SUBJECT: Case 20894: Substantive Amendments to an Existing Development Agreement for 5511 Bloomfield Street, Halifax

Application by WSP Canada Inc.

ATTACHMENT A: PROPOSED AMENDING DEVELOPMENT AGREEMENT

Schedule B.1

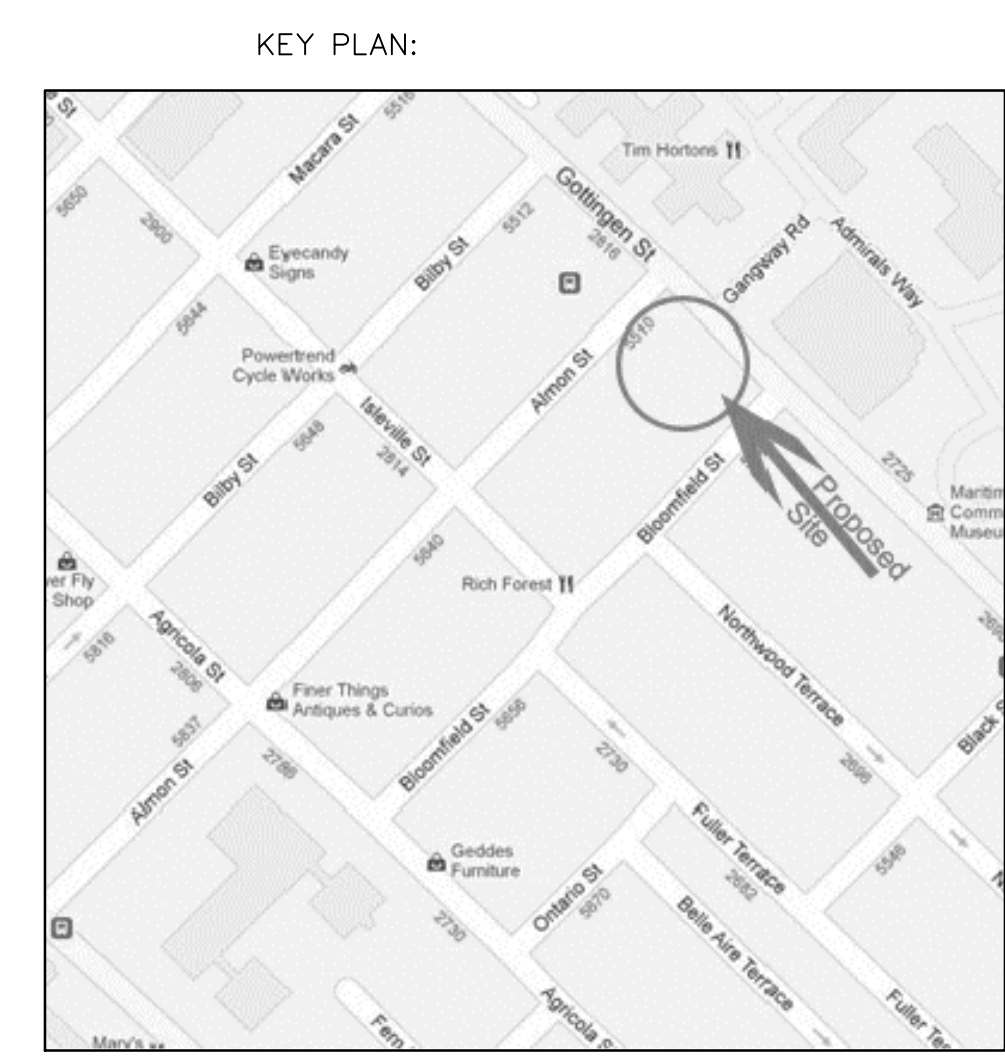
4. The schedules of the Original Agreement shall be amended by deleting Schedule B, Schedule C, Schedule D, Schedule E, Schedule F, Schedule G, Schedule H, Schedule I, Schedule J, and Schedule K and inserting Schedule B.1 (attached), Schedule C.1 (attached), Schedule D.1 (attached), Schedule E.1 (attached), Schedule F.1 (attached), Schedule G.1 (attached), Schedule H.1 (attached), Schedule I.1 (attached), and Schedule J.1 (attached).

- a) deleting all references to "Schedule B" and replacing each with a reference to "Schedule B.1"
- b) deleting all references to "Schedule C" and replacing each with a reference to "Schedule C.1"
- c) deleting all references to "Schedule D" and replacing each with a reference to "Schedule D.1"

Schedule D.1

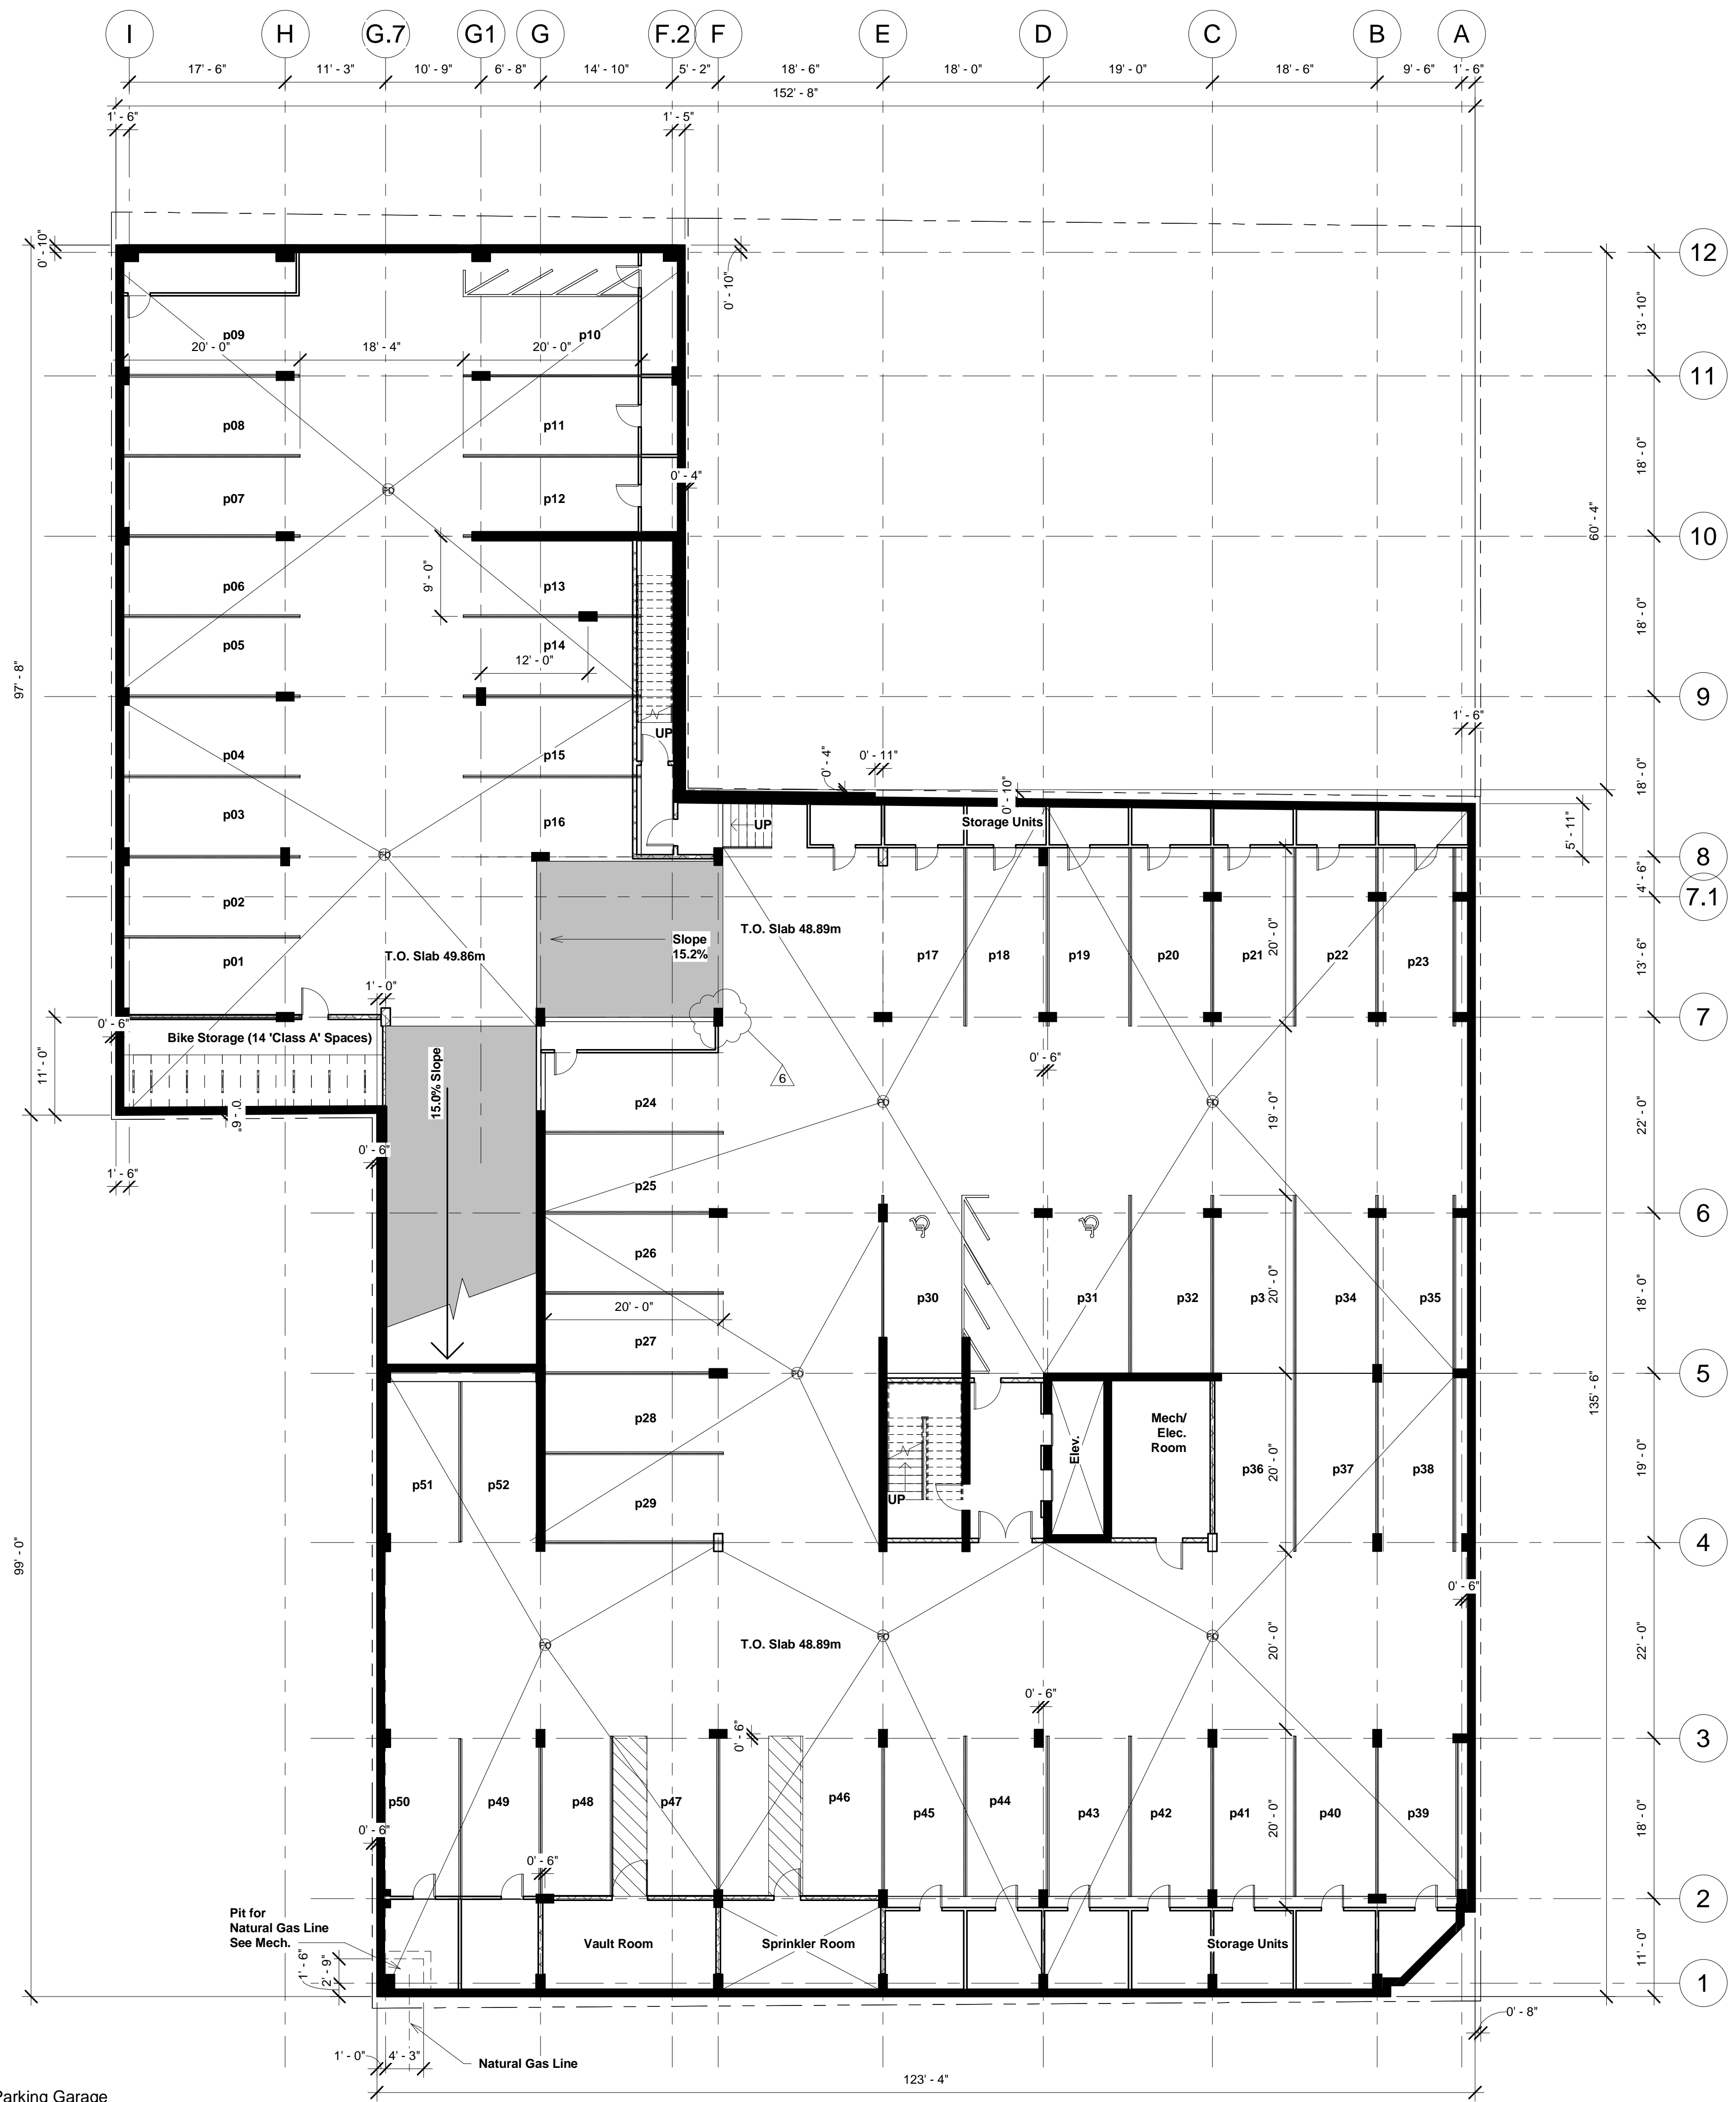
- 3.14.1 Vehicular parking shall include ~~a combination of~~ underground parking ~~and exterior surface parking~~ to accommodate a minimum of ~~70~~ **72** vehicular parking spaces. Up to 25 percent of the parking spaces may be reduced in size to 8 feet by 17 feet.

Schedule E.1

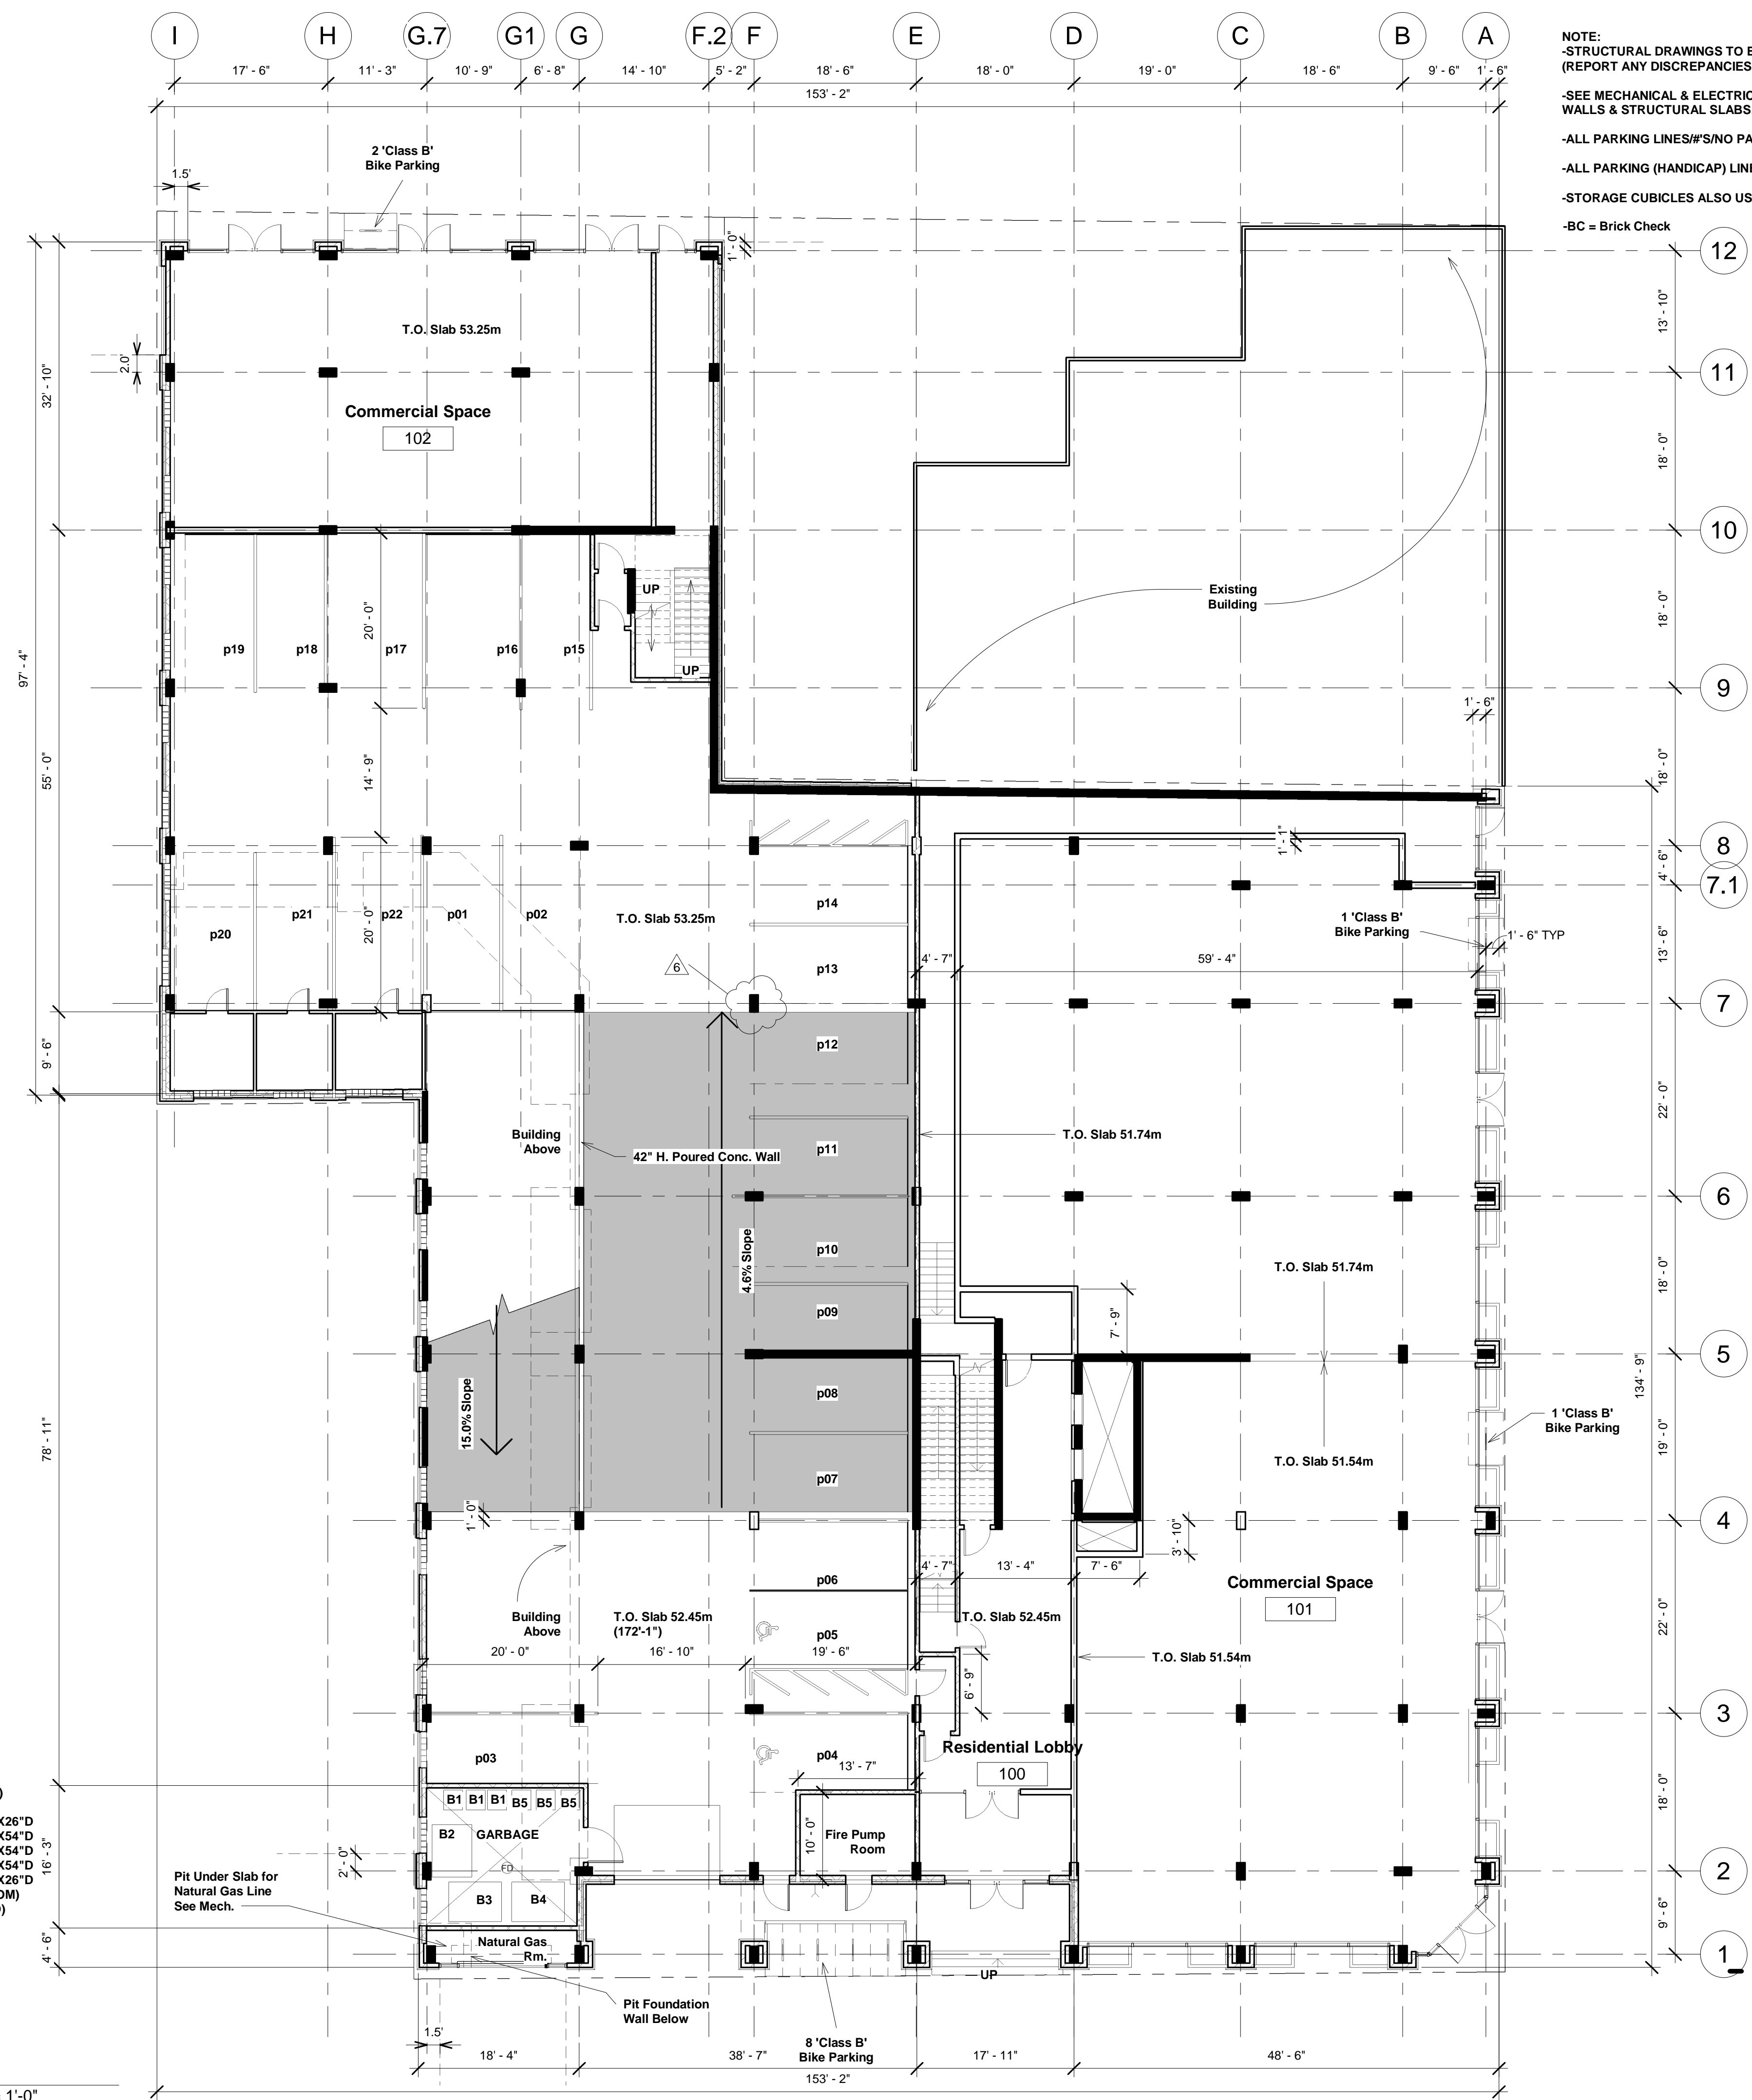
- d) deleting all references to "Schedule E" and replacing each with a reference to "Schedule E.1"
 - e) deleting all references to "Schedule F" and replacing each with a reference to "Schedule F.1"
